RESPONSE TO REQUEST FOR ADDITIONAL INFORMATION

APR1400 Design Certification

Docket No. 52-046

RAI No.:	**416-8358**
SRP Section:	**SRP 19**
Application Section:	**19.1**
Date of RAI Issued:	**02/23/2016**

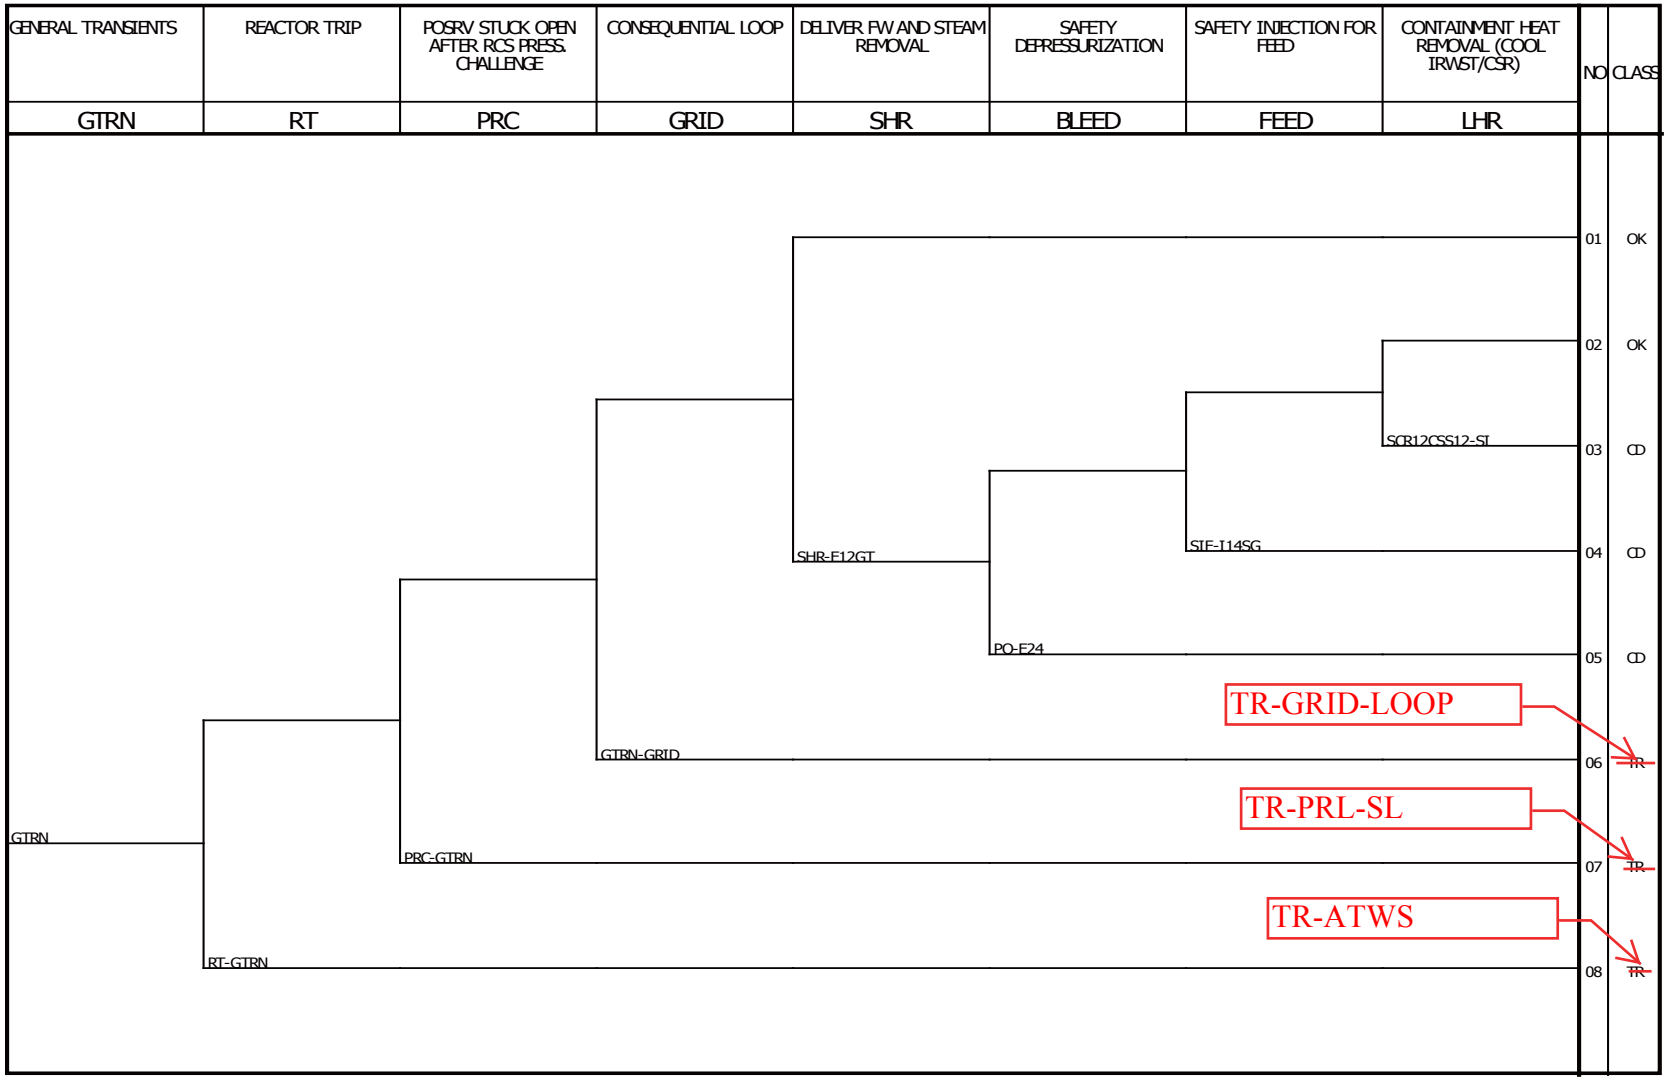
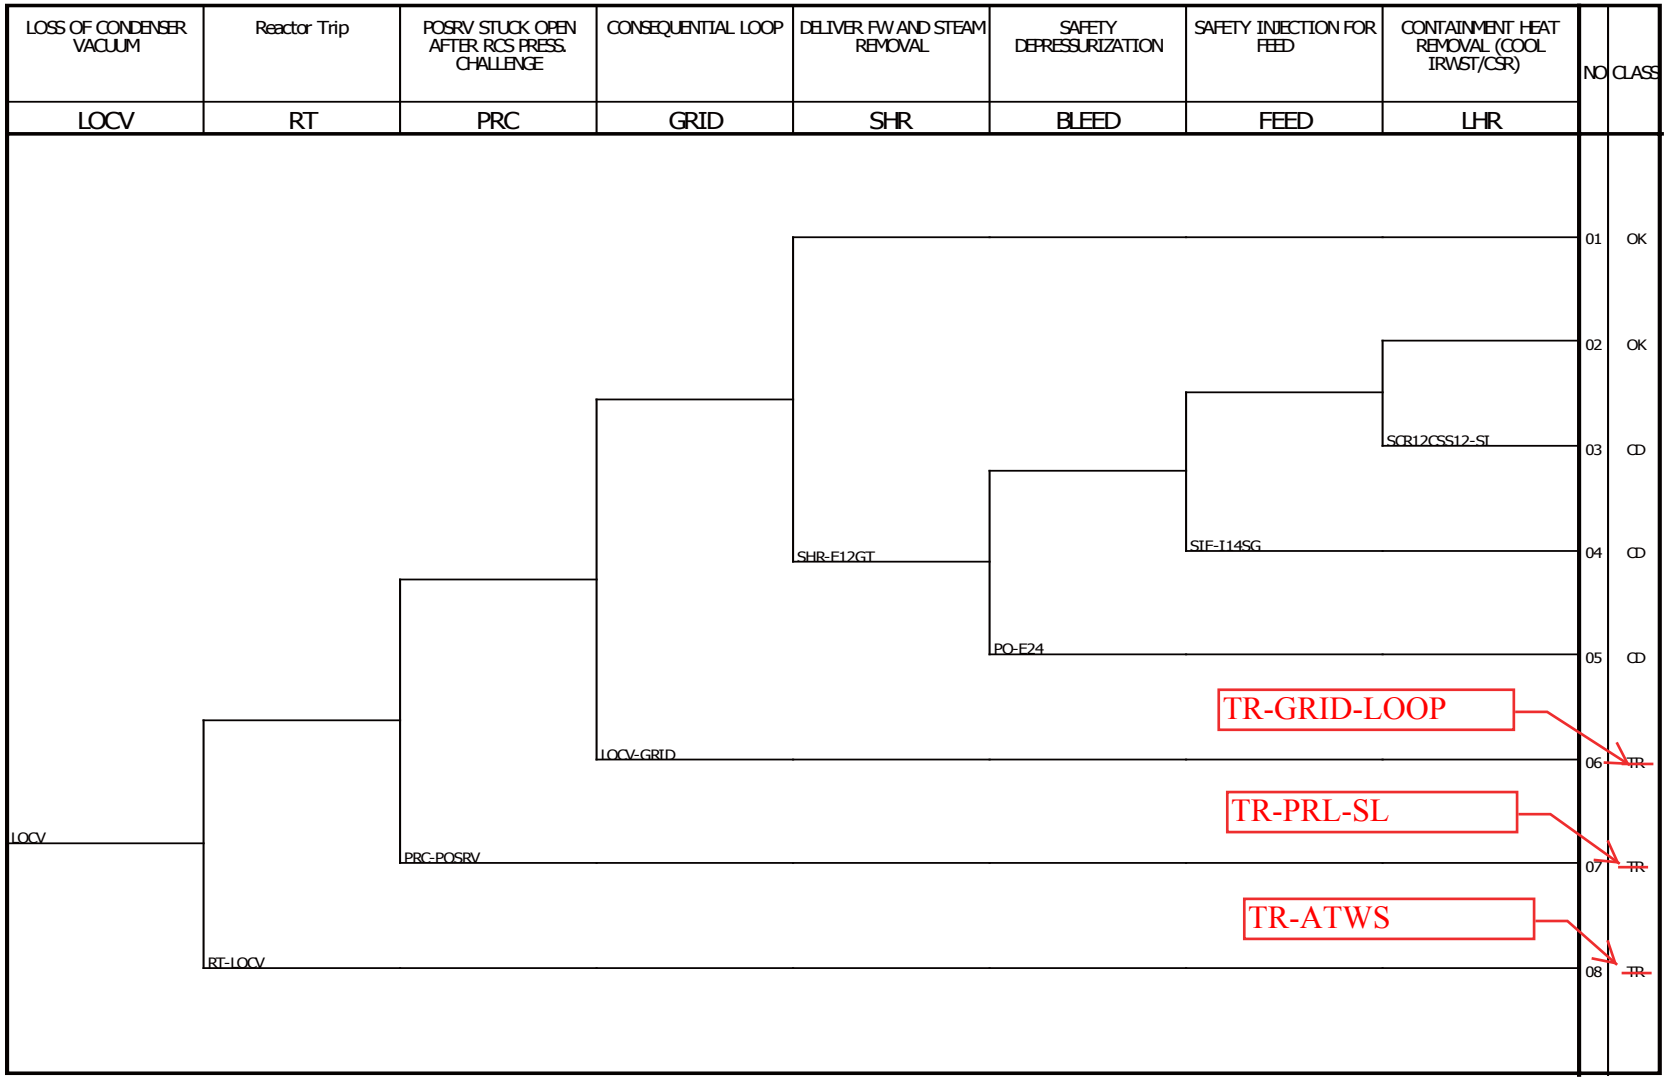
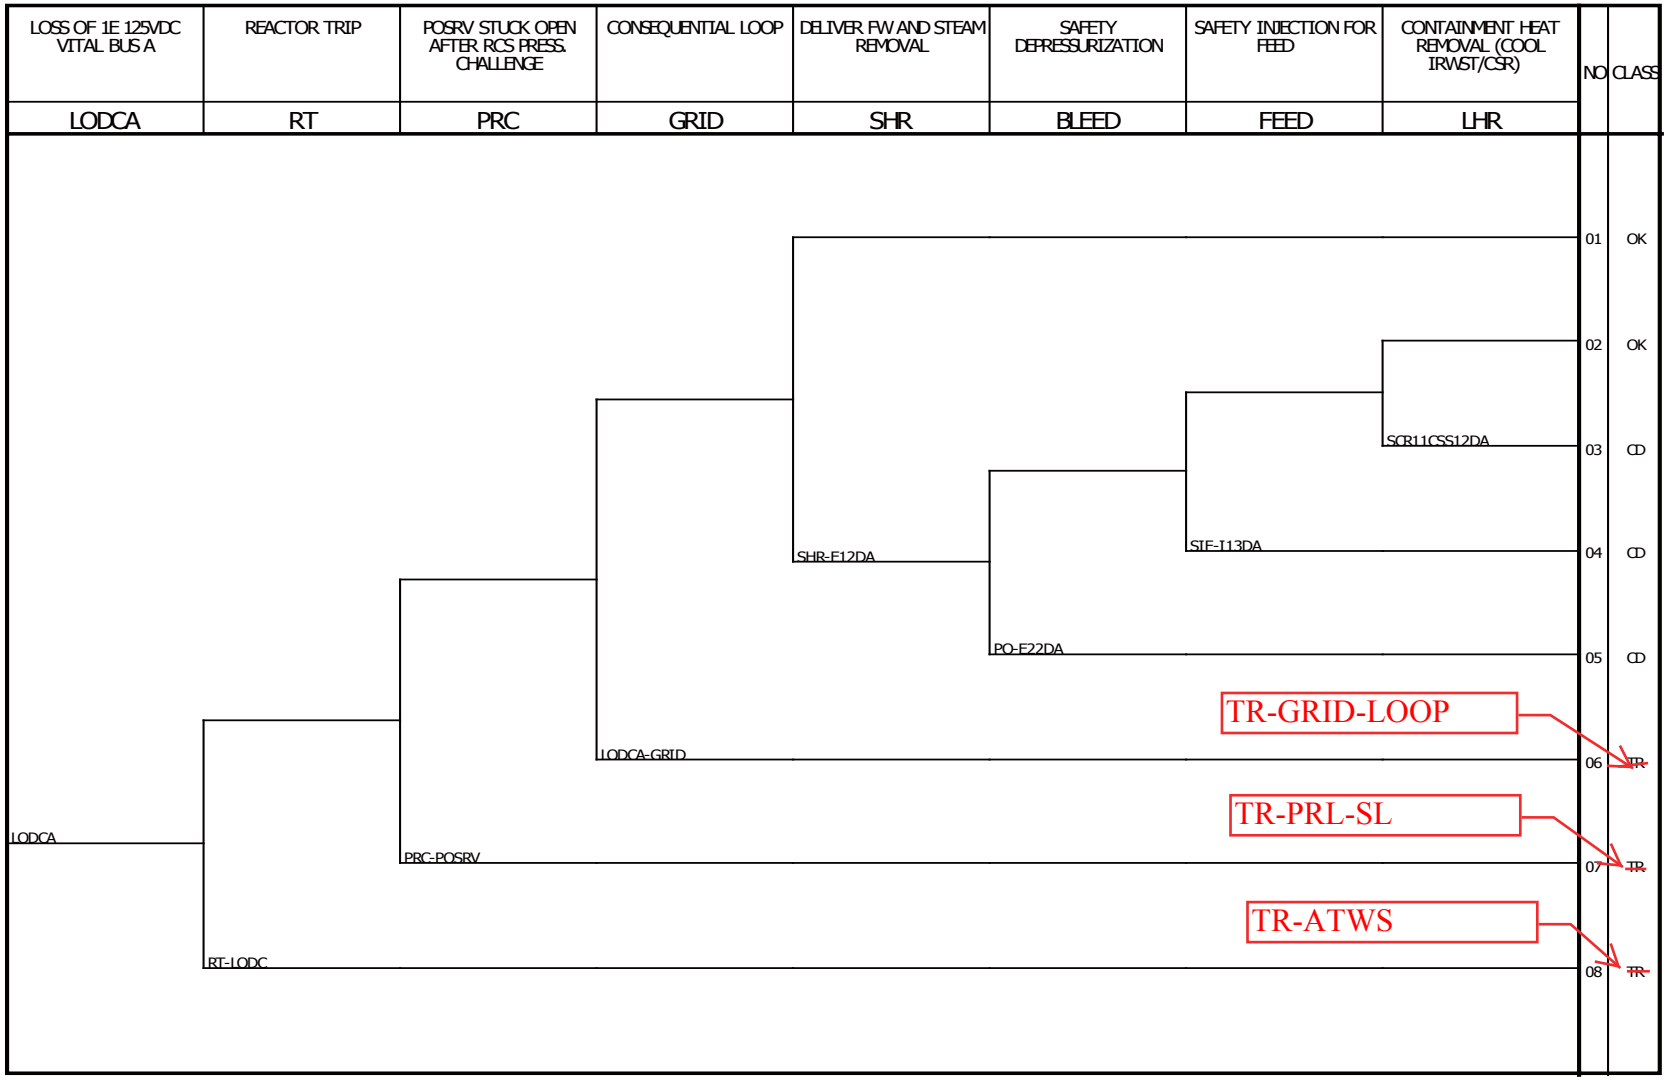
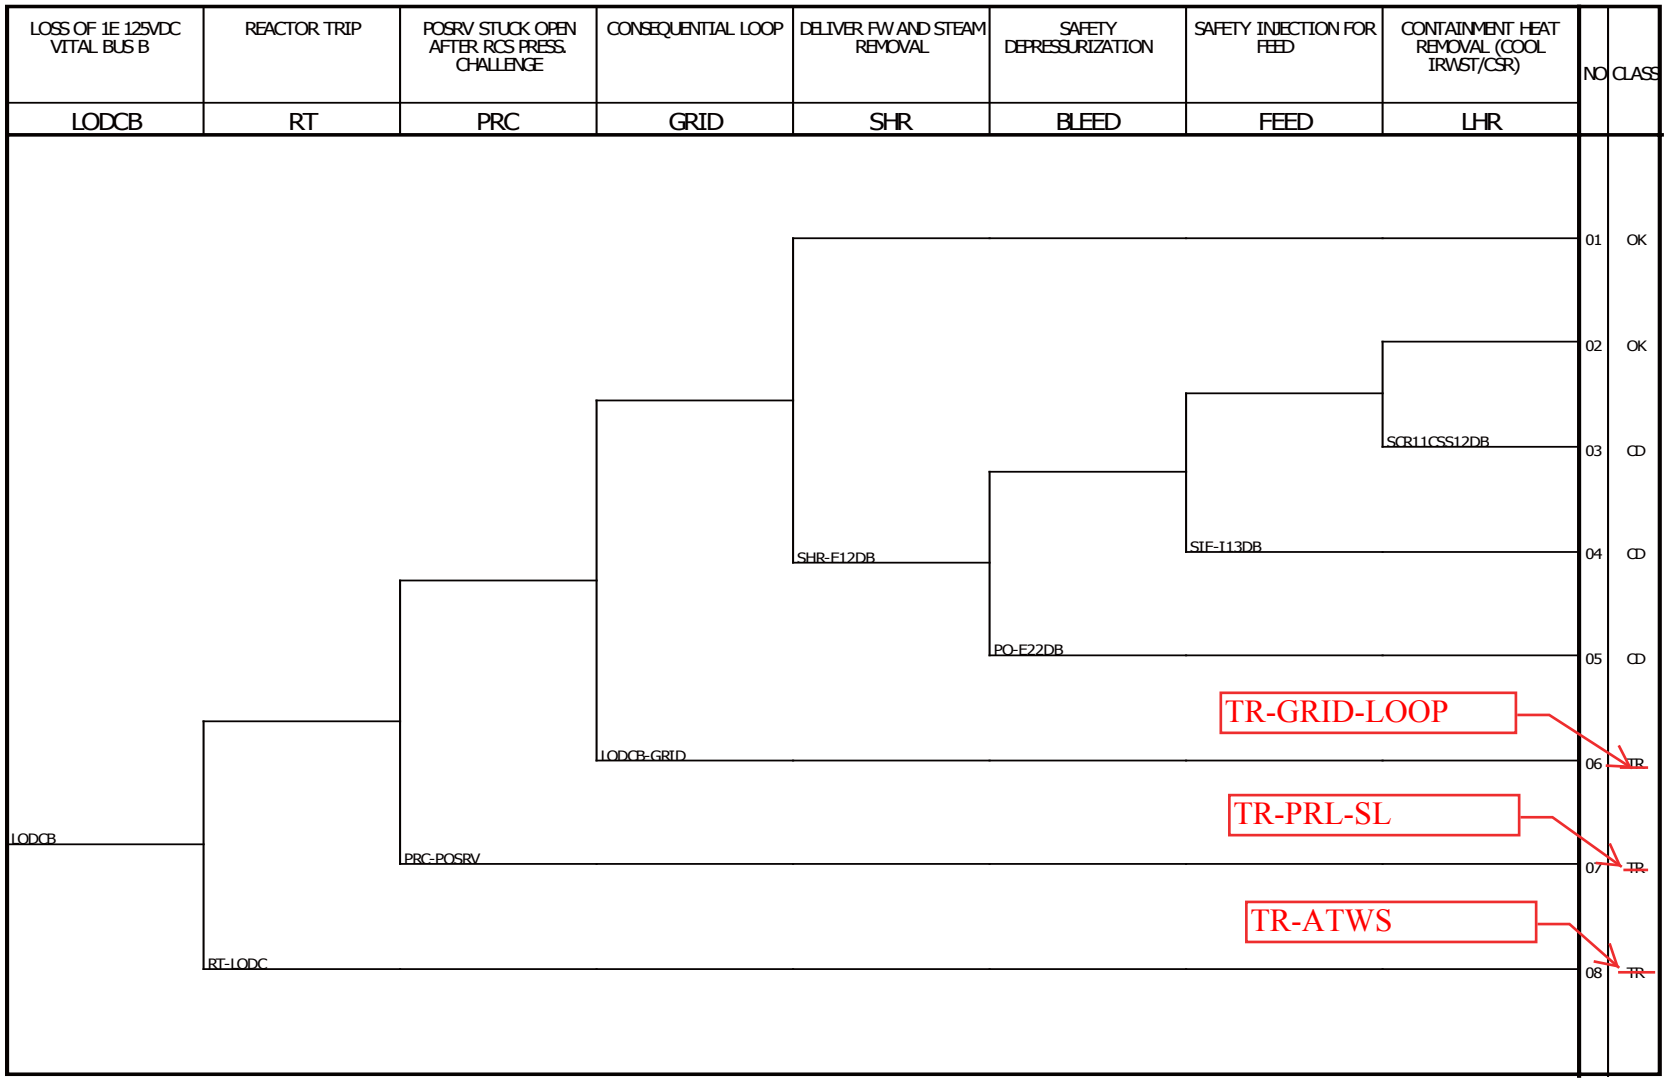
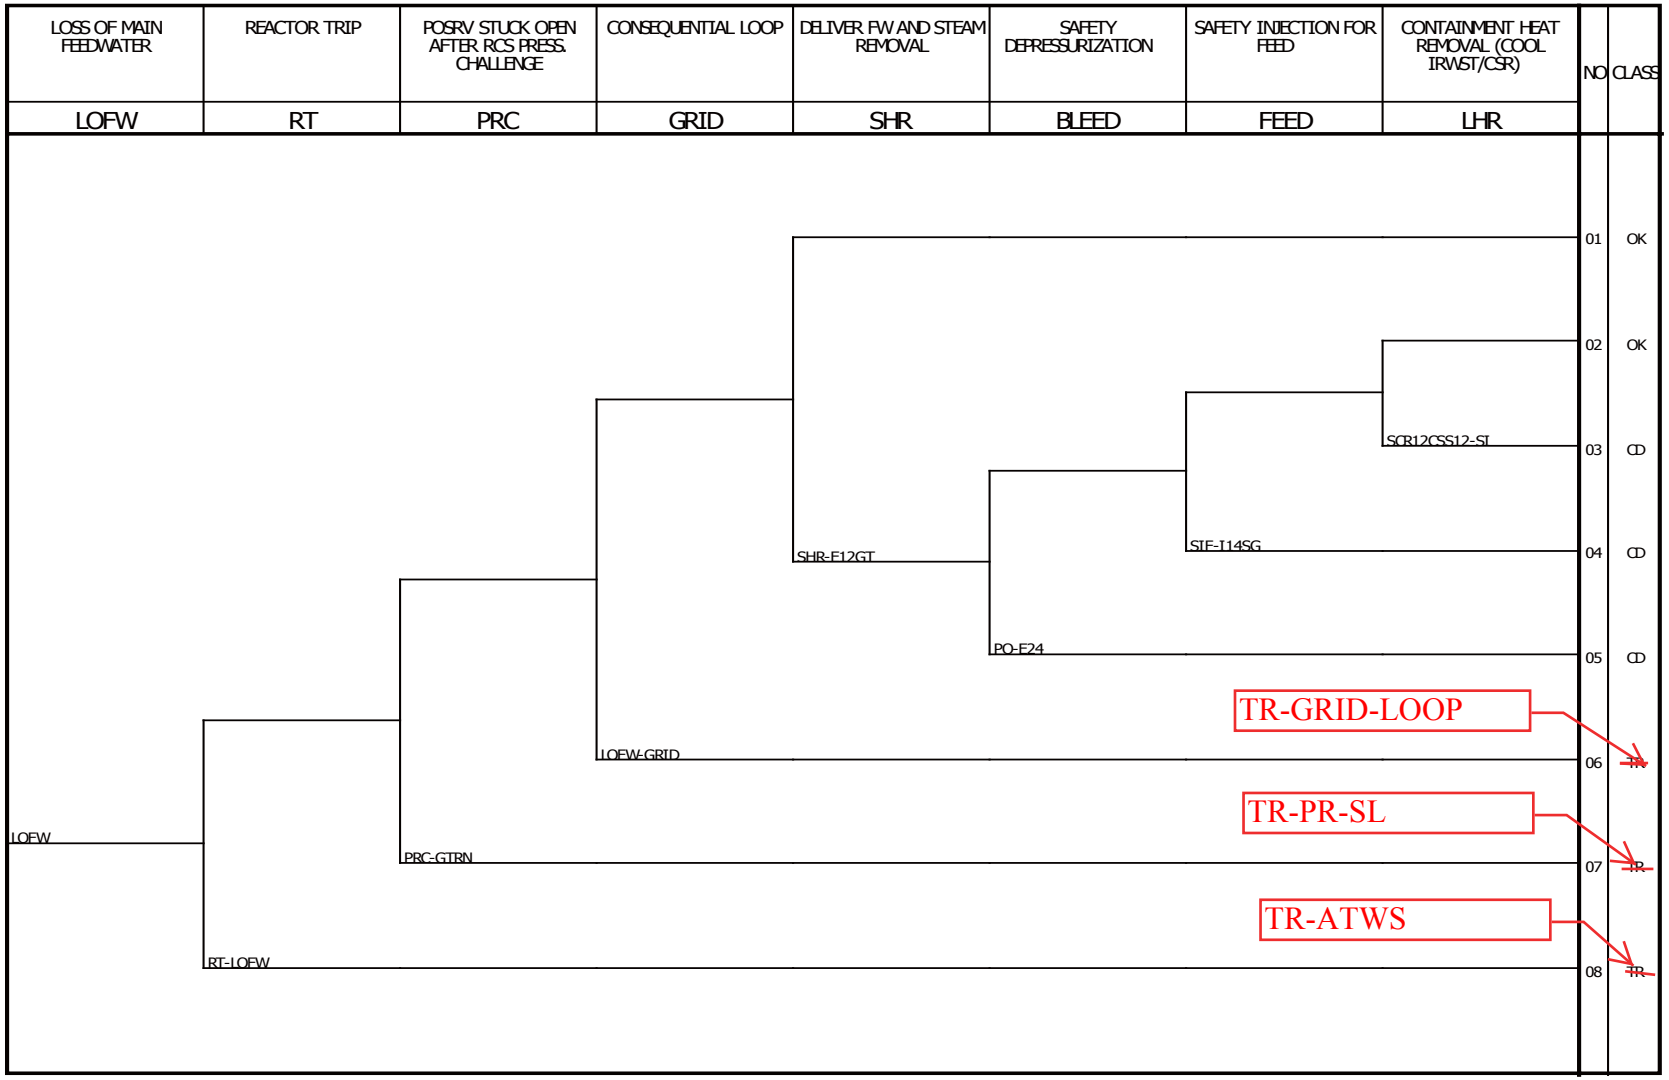
2 The transfers shown in the event trees to not identify the trees they transfer to

2. The pictures of the event trees provided in the DCD with transfer sequences will be revised to identify the event tree to which it is being transferred. Attachment 2 contains the revised event tree pictures.

The revised pictures include an identifier to indicate to which event tree the sequence is transferred. Obviously, transfer sequences which include failure of reactor trip transfer to the ATWS event tree (TR-ATWS), transfer sequences which include stuck open POSRVs transfer to the stuck-open POSRV event tree (TR-PR-SL), transfer sequences with include consequential LOOP transfer to the consequential LOOP event tree (TR-GRID-LOOP), LOOP sequences with failure of all DGs transfer to the SBO event tree (TR-SBO) , and finally GRID-LOOP sequences with failure of all DGs transfer to the GRID-SBO event tree (TR-GRID-SBO).
